ARMSTRONG WAREHOUSE JSP25-34

Public hearing at the request of David Armstrong for approval of Special Land Use, Preliminary Site Plan, and Stormwater Management Plan. The subject property is located at 22735 Heslip Drive and consists of approximately 1.31 acres, situated north of Nine Mile Road and east of Novi Road (Section 26). The property is zoned I-1 (Light Industrial). The applicant proposes construction of a 4,000 square-foot warehouse/workshop building.

PLANNING REVIEW

PLAN REVIEW CENTER REPORT

DATE: 12-12-25
SCALE: HOR: 1" = 20'
VER: 1" = N/A
DESIGNED BY: A.W.
JOB NO.: 25142
DRAWN BY: B.T.C.
SHEET: CE-3

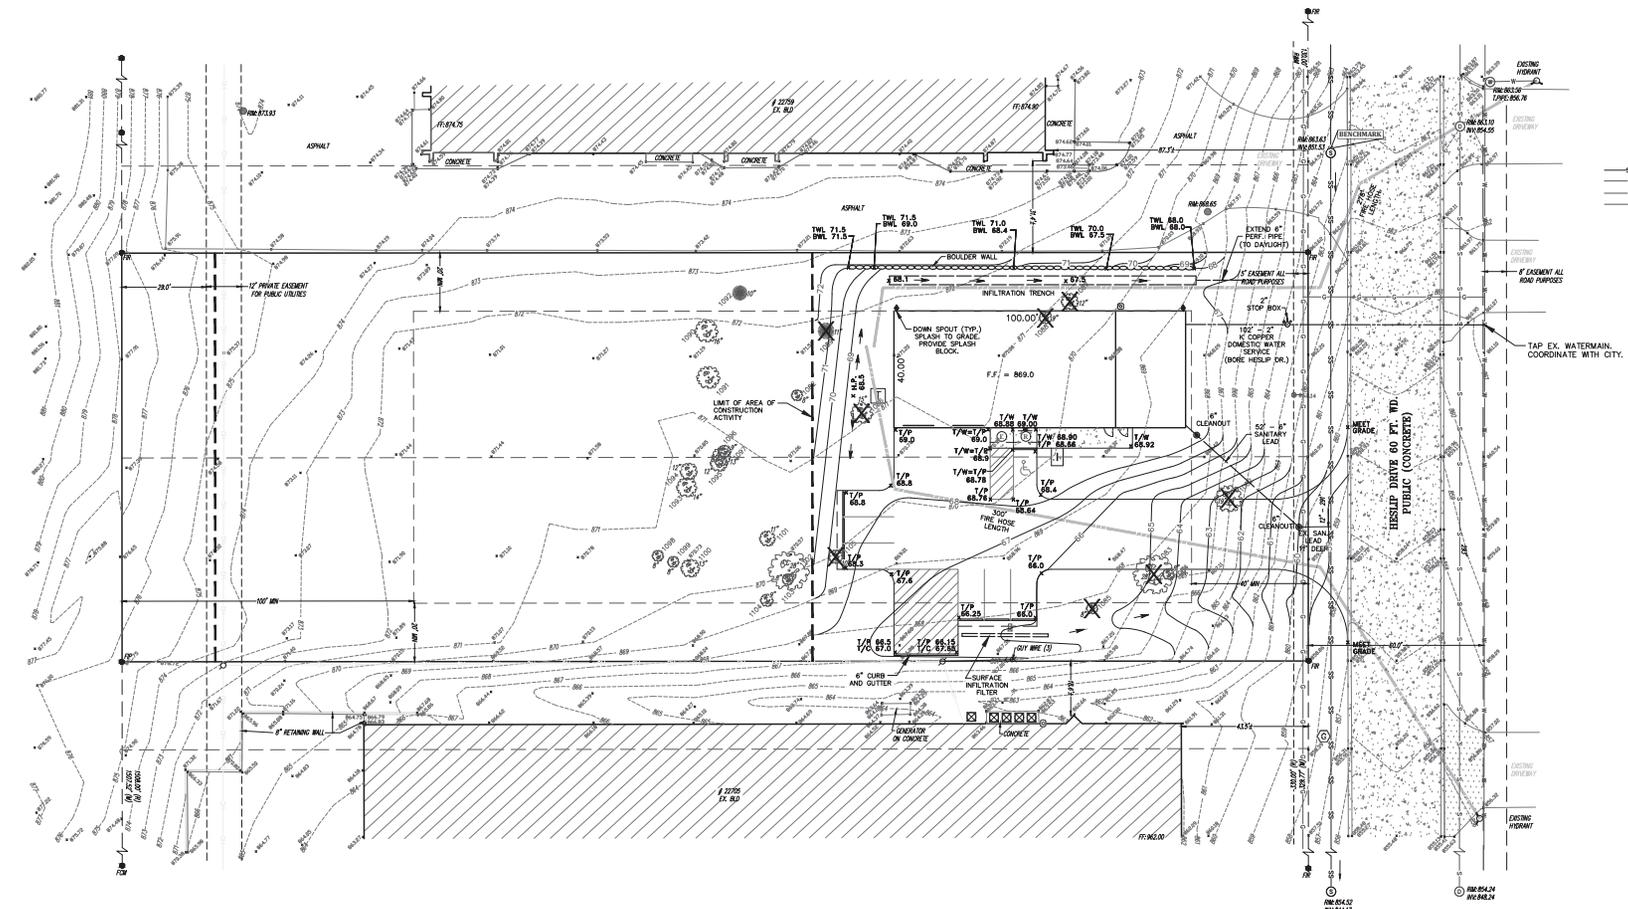
3. Bicycle Parking Lot Layout (Section 5.16.5.A): Bicycle parking layout dimensions shown on Sheet CE-3 do not meet ordinance requirements. **Please update layout dimensions per the illustration in Section 5.16.6.**

Conditional Approval is granted at this time. Submit full utility prints and adjust plan set, page CE-3 for fire truck turning radius to 50' with a truck length of 48.5' (see attached spec sheet for details).

- The entrance drive will be designated as a fire lane, if deemed necessary by the Fire Chief and signs will be installed as required.
- The west end of the proposed building is 142-feet west of the property line. Fire access is provided by the 24' wide driveway, which extends 150-feet from Heslip Drive. See Sheet CE-3.

- The fire apparatus access drive to the building as proposed, has a 50-foot outside turning radius and is designed to support a minimum 35 tons. Please refer to Sheet CE-3.

- Interior fire suppression is not proposed.
- No new hydrants are proposed.
- There are two existing hydrants which provide fire protection for this project. All parts of the building are within 300-foot hose laying distance from the hydrants. See Sheet CE-3.

- The truck turning radius on Sheet CE-3 has been adjusted to 50' with a truck length of 48.5' and will be submitted with the Final Site Plan.

DATE: 12-12-25
SCALE: HOR: 1" = 20'
VER: 1" = N/A
JOB NO.: 25142
DESIGNED BY: A/W
DRAWN BY: PTC
SHEET: CE-4

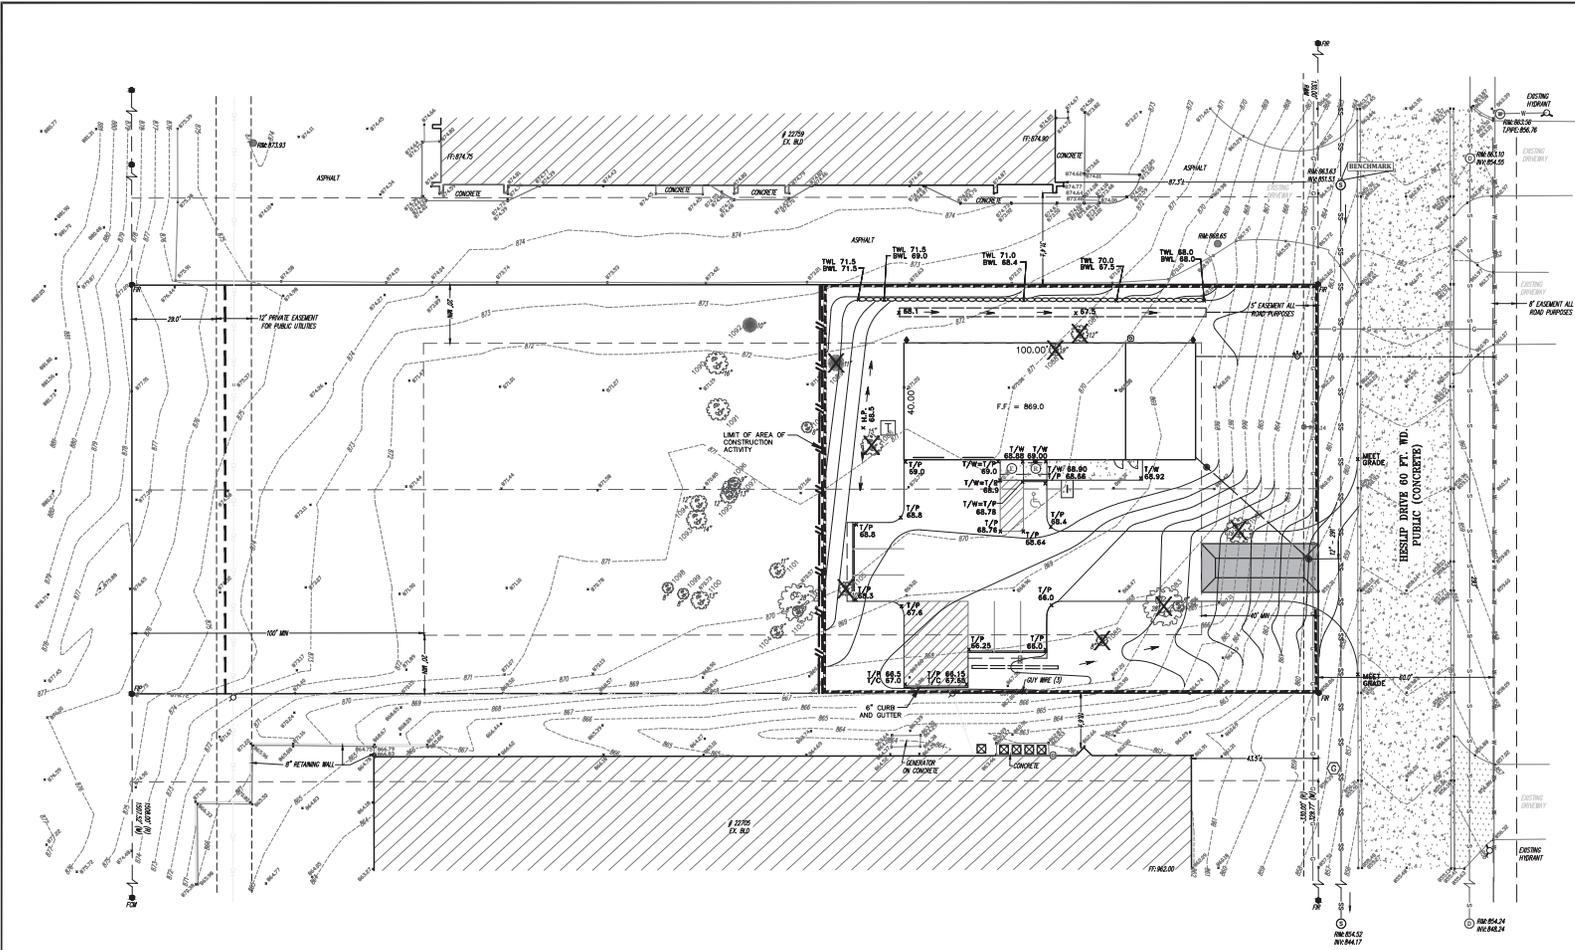
4. More clearly highlight where the proposed light poles are to be located on sheet CE-4.
5. Provide a note that compacted sand backfill (MDOT sand Class II) shall be provided for **all** utilities within the influence of paved areas.

9. Show the locations of all light poles on the utility plan and indicate the typical foundation depth for the pole to verify that no conflicts with utilities will occur. Light poles in a utility easement will require a License Agreement.

3. A same side driveway spacing waiver has been requested. Thank you for your support.
4. The proposed light poles will be shown more clearly on Sheet CE-4.

Figure 1. City of Novi Regulated Woodlands Map
Approximate Site boundary is shown in red.
Approximate Regulated Woodland areas are shown in green.
Expanded Regulated Woodland areas are shown in orange.

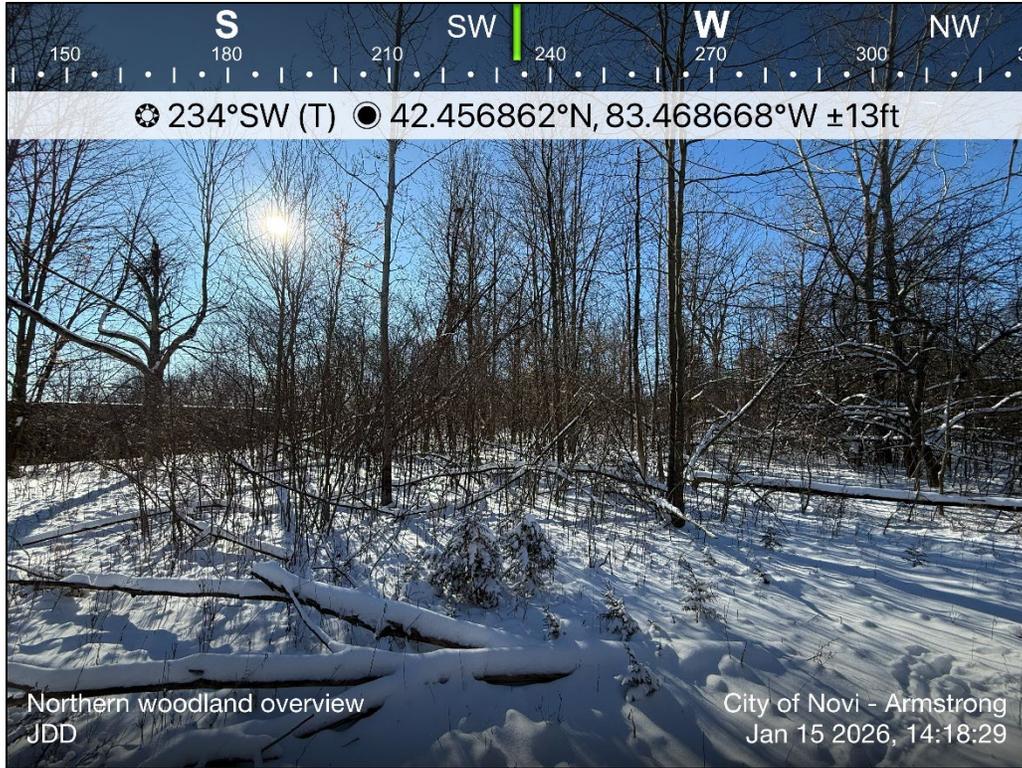
- b. An updated outline of regulated woodland areas is provided in **Figure 1**. The regulated woodland area on-site is relatively consistent with the “Tree Protection Fencing” and “Disturbance Limits” provided on Sheet L-1 in the Site Plan.
